International Aero Engines SERVICE BULLETIN

ENGINE - POWER PLANT - EEC HARNESS FAN - CONTROLLED
SERVICE USE OF ALTERNATIVE CONNECTOR SOCKETS

V2527-A5
V2530-A5

V2500-ENG-71-0158

Figure 1

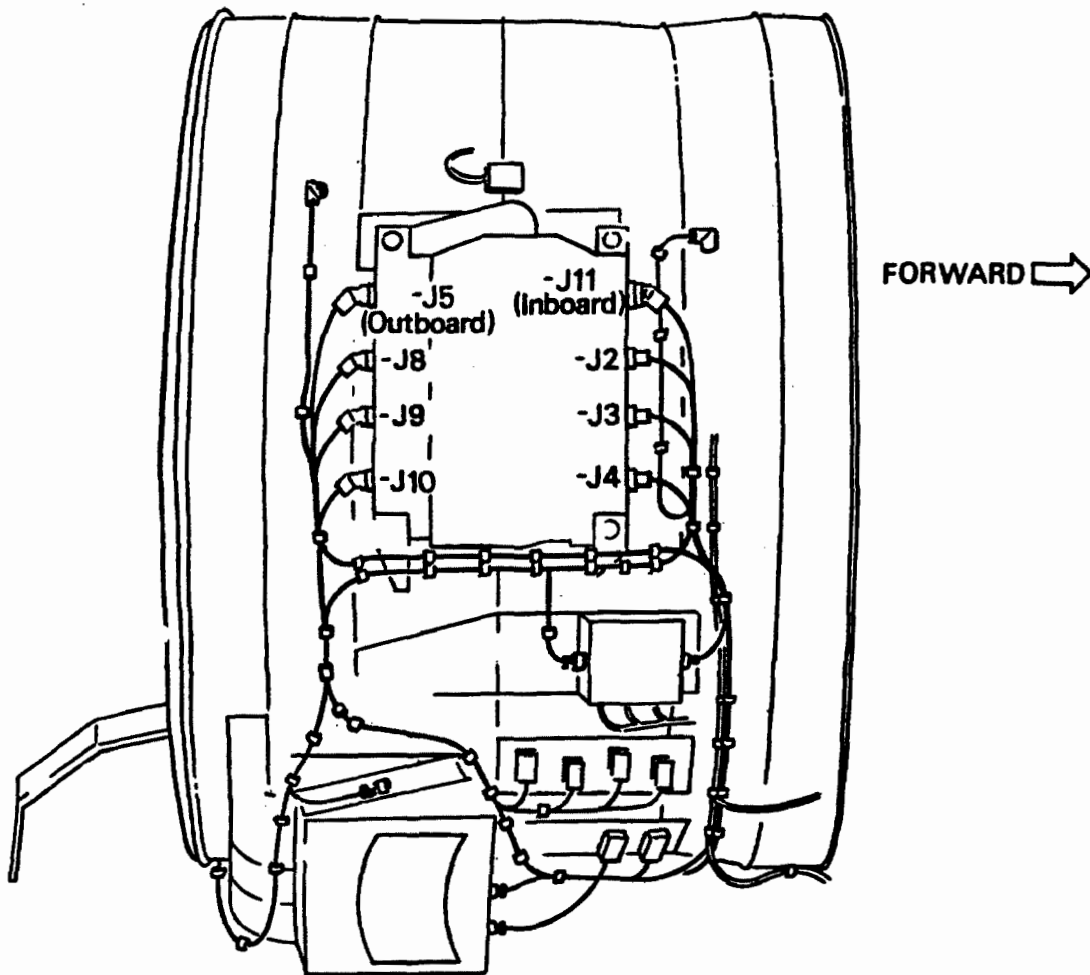
- (1) Open the Fan Cowl doors using the approved procedure in Reference (1), Chapter/Section 71-13-00.
- (2) Disconnect the 4000KS-J4 and 4000KS-J10 electrical connectors from the EEC using an IAE 1J12018 EEC harness wrench. Refer to Figure 1.
- (3) Disconnect the 4017KS-A electrical connector from the fuel temperature thermocouple on the FCOC. Refer to Figure 2.
- (4) Remove the existing sockets from contact positions C & D of the 4000KS-J4 and 4000KS-J10 electrical connectors on the EEC Fan harness and replace with the sockets specified in the table below. Use the approved procedures in Reference (2), Chapter/Section 20-71-21.
- (5) Remove the existing sockets from contact positions 2, 3, 5 and 6 in the 4017KS-A electrical connector on the EEC Fan harness and replace with the sockets specified in the table below. Use the approved procedures in Reference (2), Chapter/Section 20-71-21.

- (6) Connect the 4000KS-J4 and 4000KS-J10 electrical connectors to the EEC and torque to 32 lbfin (3,6 Nm) using the IAE 1J12018 EEC harness wrench. Refer to Figure 1.
- (7) Connect the 4017KS-A electrical connector to the fuel temperature thermocouple on the FCOC and torque to 18 lbfin (2,0 Nm). Refer to Figure 2.

Connector	Contact	Replacement Socket No.
4000KS-J4	C	T3-4120-10P
	D	T3-4120-10R
4000KS-J10	C	T3-4120-10P
	D	T3-4120-10R
4017KS-A	2	BT-4116-10P-Y165
	3	BT-4116-10R-Y165
	5	BT-4116-10P-Y165
	6	BT-4116-10R-Y165
